Wednesday, July 10, 2019 at 1:00 PM
Planning Department Staff Analysis

N.2 Case No: A-19-1243333 Parcel ID(s): 18-109-03-009

Project Name: 1555 LaVista Road

REQUEST: Appeal to a denial of a stream buffer variance (Section 14-44.4 of the DeKalb County Land Development Ordinance) to relocate an existing pool pump building located within the DeKalb County's Stream Buffer.

1 PROPOSED
A1.00 SCALE: 1/4" = 1'-0"

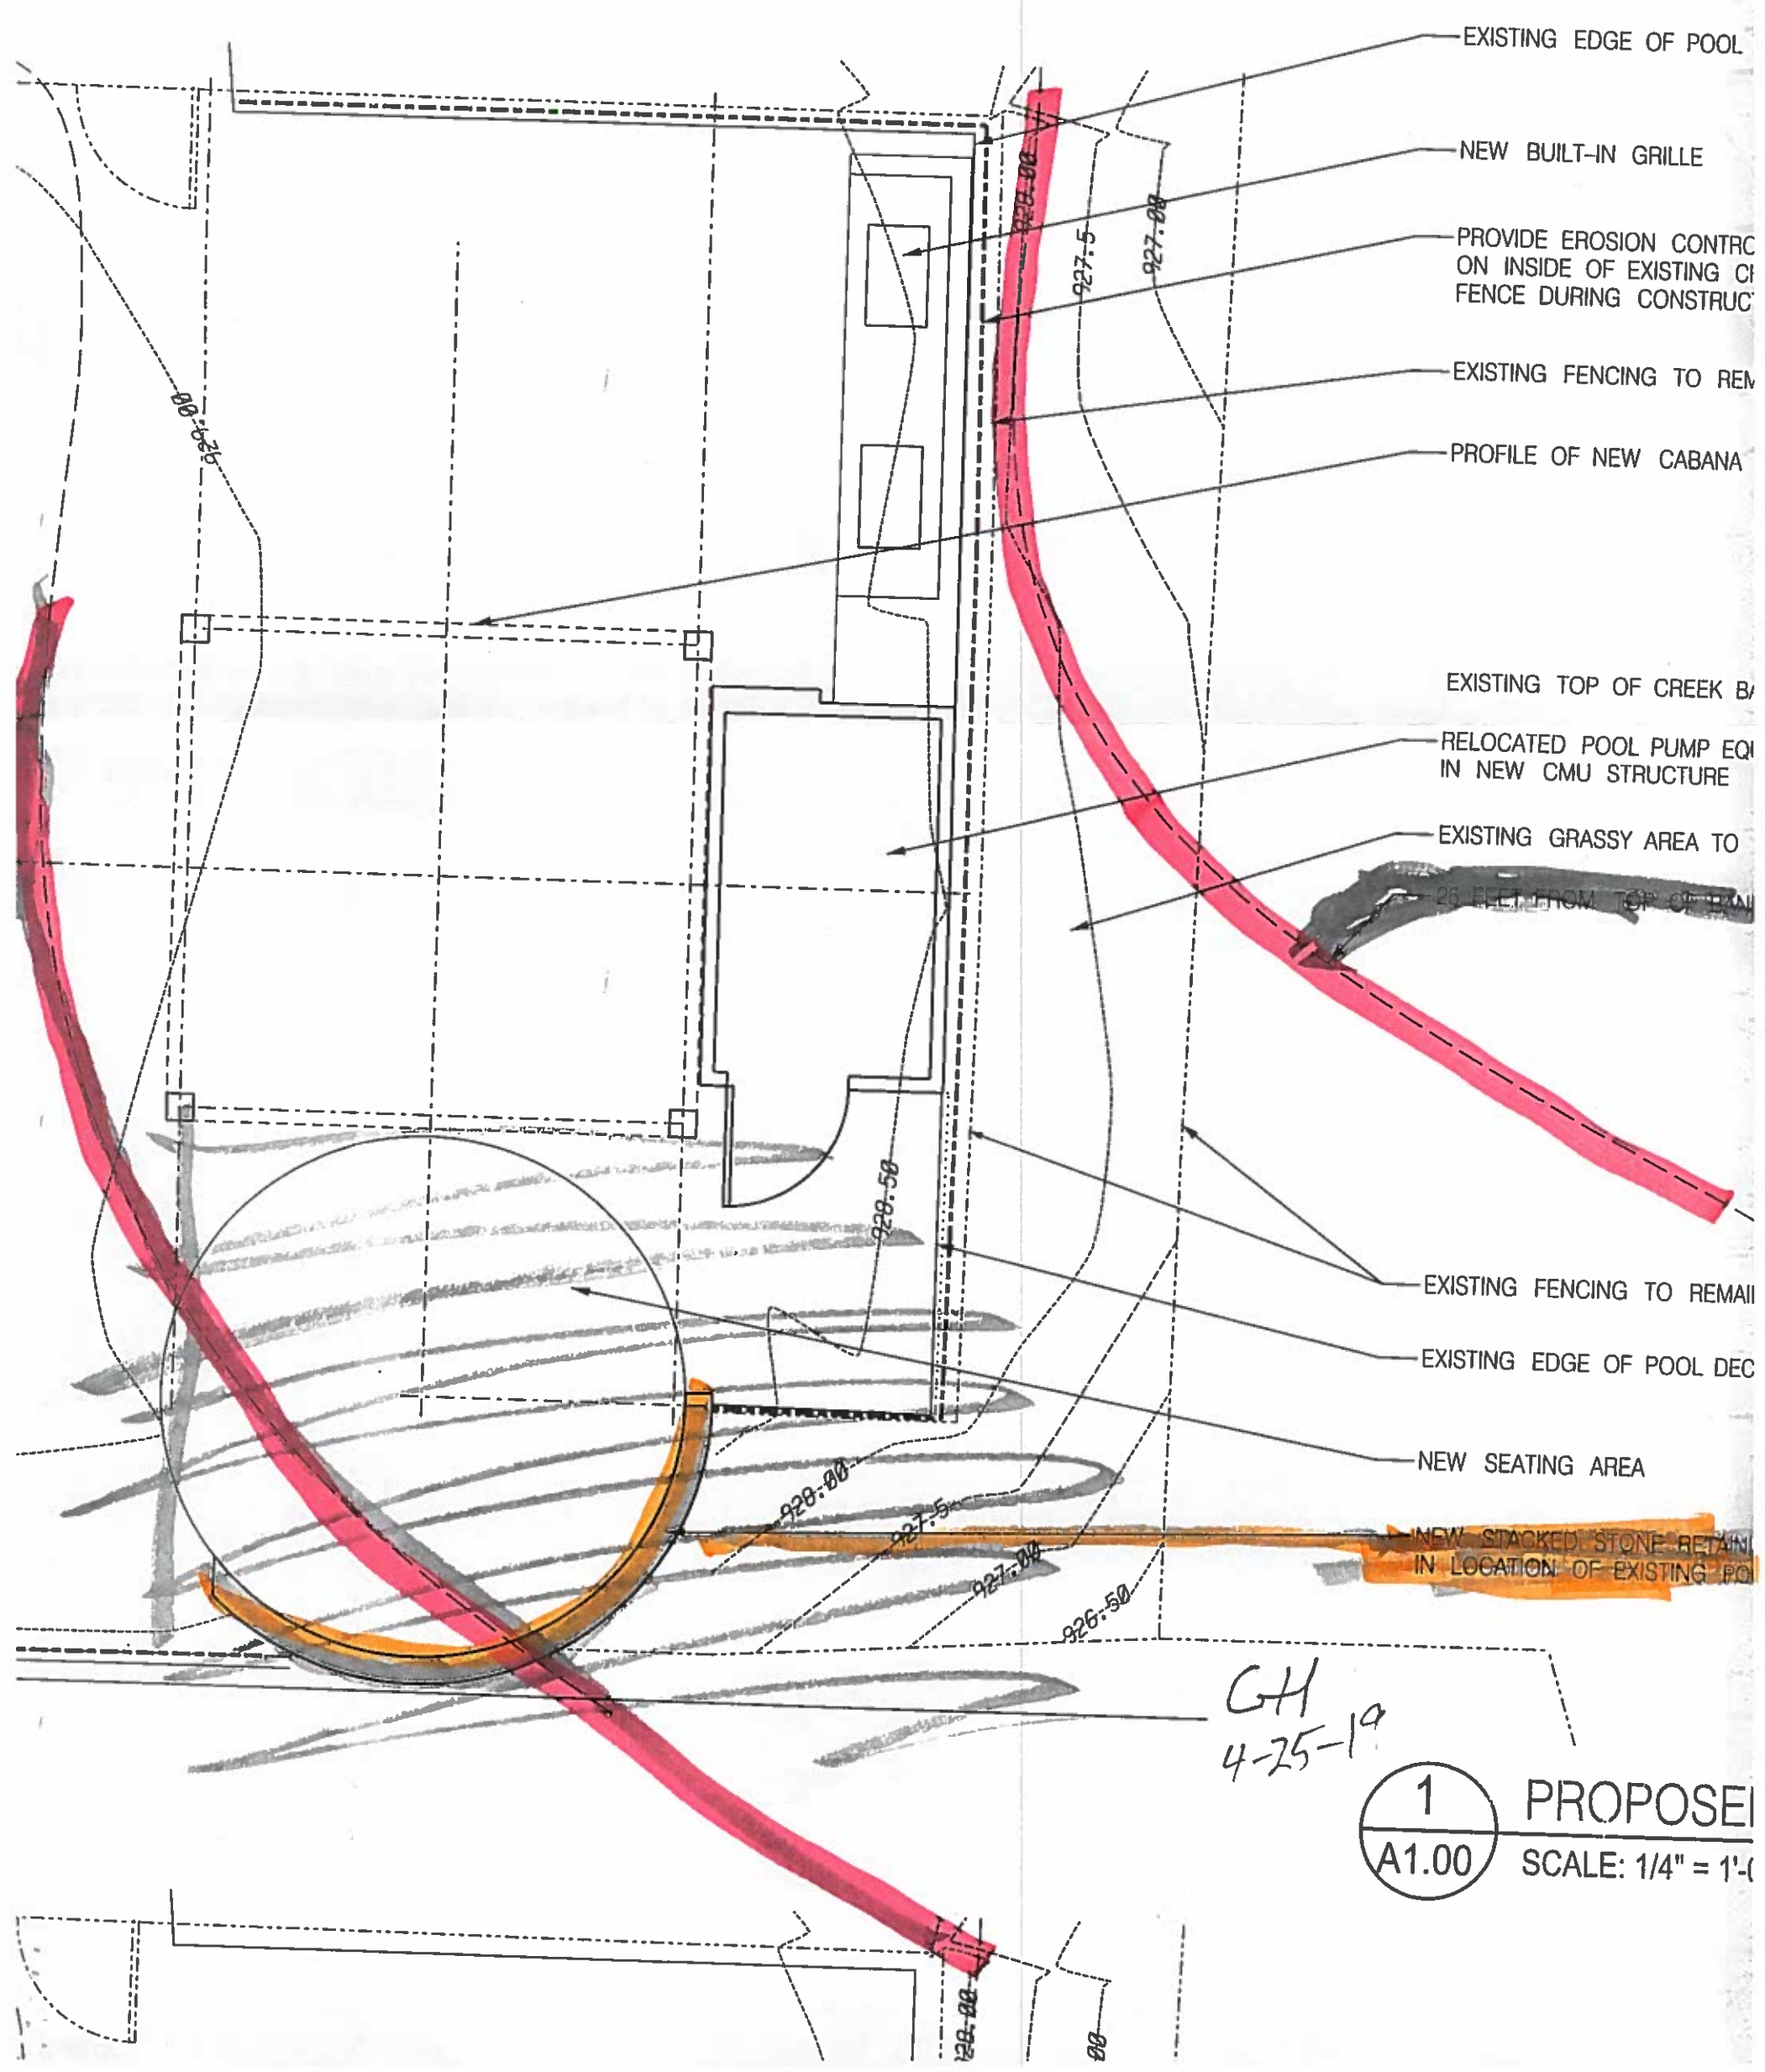
Stream Buffer
Pool Deck, Grille Area, Pump House
Re-Build in separate location
* Retaining wall shown on plans 30' from Stream.

Denial
More than Allowed under code
14.44.1 (b)(4) + (5)(B)

The purpose this stream buffer variance is to allow for renovations of an existing pool deck and relocation of a pool pump building at the Sloan Square Apartment, located at 1555 Lavista Road. The DeKalb County’s Stream buffer ordinance limits the Director of Planning and Sustainability to grant a variance no more than 10 feet into the outer County 25-foot stream buffer for redevelopment of existing multifamily developments that were erected prior to the enactment of the 50-foot stream buffer. The applicant was denied April 29, 2019 for a stream buffer variance to relocate an existing pool pump building that is currently located beyond 10 feet in the DeKalb County’s Stream Buffer.

The applicant has provided a detailed site plans, indicating the relocation and reconstruction of the existing pool pump building within the boundaries of the existing pool deck. Per the applicant, the area where the pool pump building is currently located will be converted into a seating area for the pool deck. The site plan also includes a new retaining wall and new concrete pool deck in place of the existing pool bump building. The resulting work if approved would not have a negative impact to the health and welfare of the Buffer, as well as the residents and wildlife in the area. Therefore, Staff recommends that the Zoning Board of Appeals finds in FAVOR of Staff's determination of APPROVAL.

STAFF RECOMMENDATION: "Approval" of the appeal to allow the stream buffer variance to be issued.
